United States Patent and Trademark Office

Office Action Summary

10/520,209

MICHAEL G. BOGART

Fig. 2

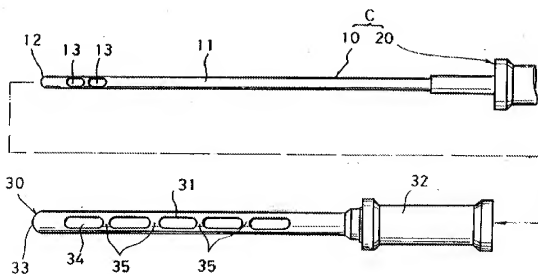
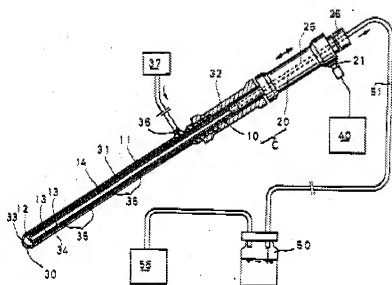
wherein the surgical hand piece (10, 20) is provided with a handle (20) and the suction tube (30) is configured with a handle (32) to form a complementary part, wherein the outside dimensions of the handle (20) of the surgical hand piece (10, 20) are adapted to those dimensions of the handle (32) of the suction tube (30), and wherein the handle (20) of the surgical hand piece (10, 20) is configured to be connectable with the handle (32) of the suction tube (32) or optionally with another complimentary part that also includes an adapted handle (see figures 1 & 2, *infra*).

Regarding the terms "injection canulla" and "suction tube", the inner and outer tubes (10, 30) of Takasu are each capable of injecting or suctioning fluids when connected to a source of positive or negative pressure.

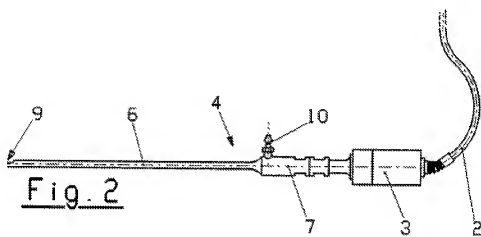
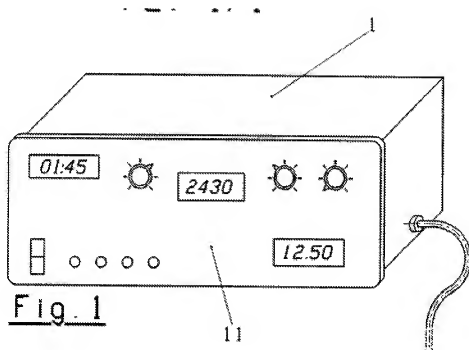
Boutboul teaches a liposuction system that has replaceable/interchangeable handles (7) that can be replaced as they become contaminated or to accommodate different sizes of canulas (6, 6')(see figures 2 & 3, *infra*).

Regarding claim 8, Takasu teaches that the inner canulla (10) clears the outer tube (30).
Boutboul teaches interchangeable canulla having different lengths (see figures 2 and 3, supra).

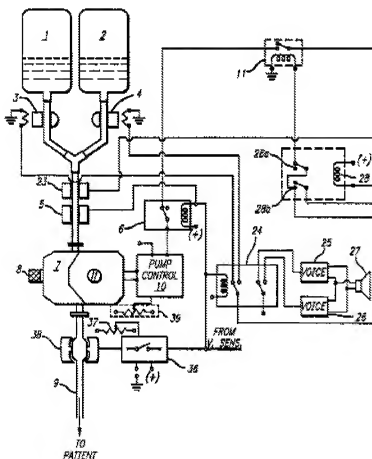
Comesu teaches a system comprising a supply pump (7) and multiple irrigation fluid sources (1, 2) selected by a switchable valve system (3, 4, 5, 6, 24)(col. 5, lines 57-67). This provides for either increased capacity over a single source of irrigation source and/or allows multiple types or irrigation sources (see fig. 2-1, *infra*).
